Administrative Order SWD-2004
November 19, 2019

**ADMINISTRATIVE ORDER
OF THE OIL CONSERVATION DIVISION**

Pursuant to the provisions of Division Rule 19.15.26.8(B) NMAC, Solaris Water Midstream, LLC. ("the Operator") seeks an administrative order for its McCrae SWD #1 ("the Proposed Well") with a location of 275 feet from the North line and 1000 feet from the East line, Unit letter A of Section 33, Township 19 South, Range 28 East, NMPM, Eddy County, New Mexico, for the purpose of produced water disposal.

Attachment: C-108 well completion diagram

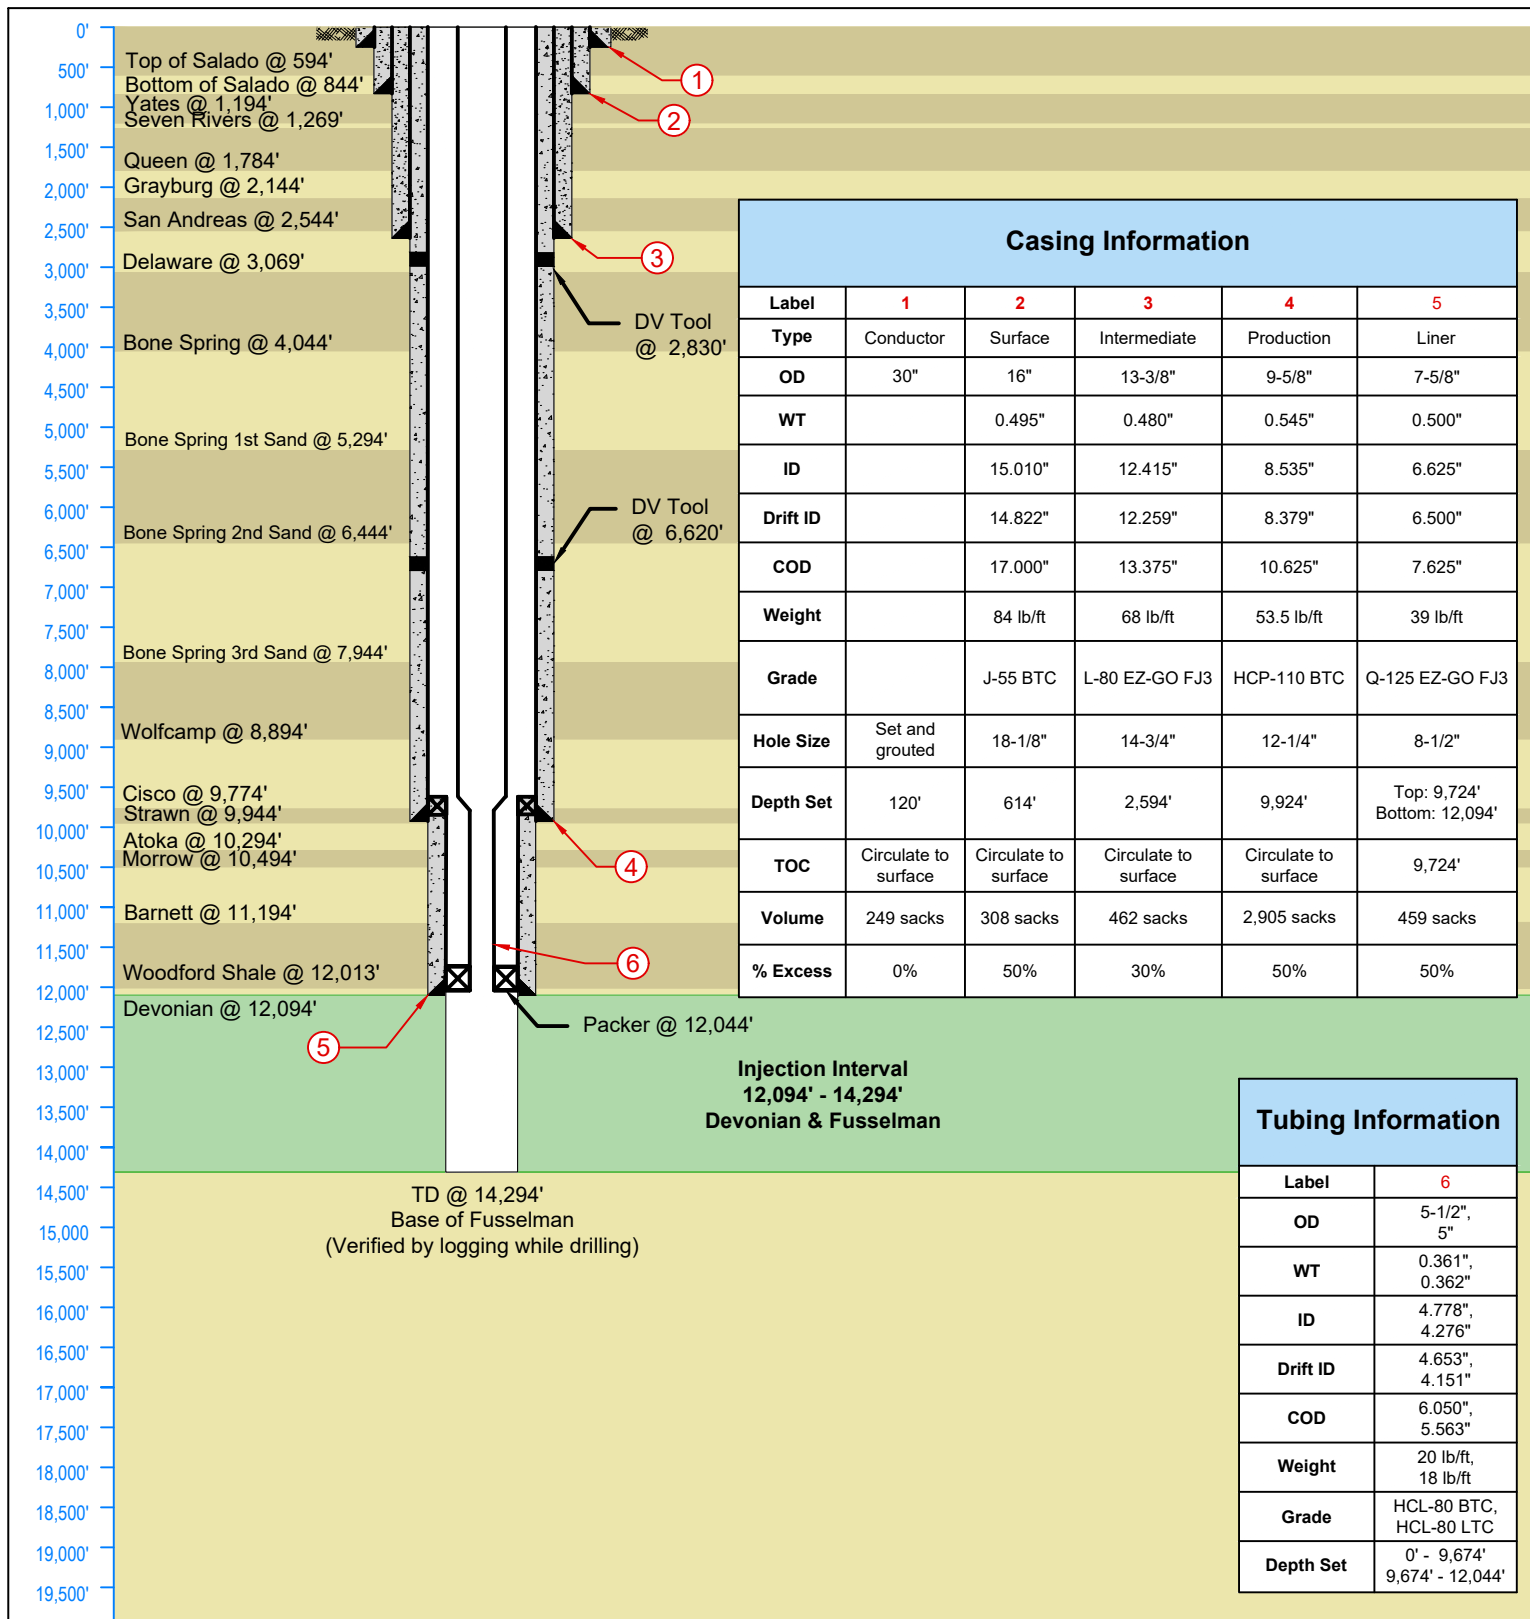
The applicant, Solaris Water Midstream, LLC. (OGRID 371643), is hereby authorized to utilize its McCrae SWD #1 (API 30-015-Pending) with a location of 275 feet from the North line and 1000 feet from the East line, Unit letter A of Section 33, Township 19 South, Range 28 East, NMPM, Eddy County, for disposal of oil field produced water (UIC Class II only) through open-hole completion into an interval consisting of the Devonian and Silurian formations from

approximately 12,094 feet to approximately 14,294 feet. Injection will occur through internally-coated, 5½-inch or smaller tubing within the 9⅝-inch production casing and 5 inch or smaller tubing within the 7⅝-inch liner with a packer set within 100 feet of the top of the disposal interval.

The operator shall circulate to surface the cement for the 9⅝-inch production casing.

The operator shall run a CBL (or equivalent) for the 7⅝-inch liner to demonstrate the placement of cement and the cement bond with the tie-in with 9⅝-inch production casing string. The operator shall provide a copy of the CBL to the Division's District office prior to commencing disposal.
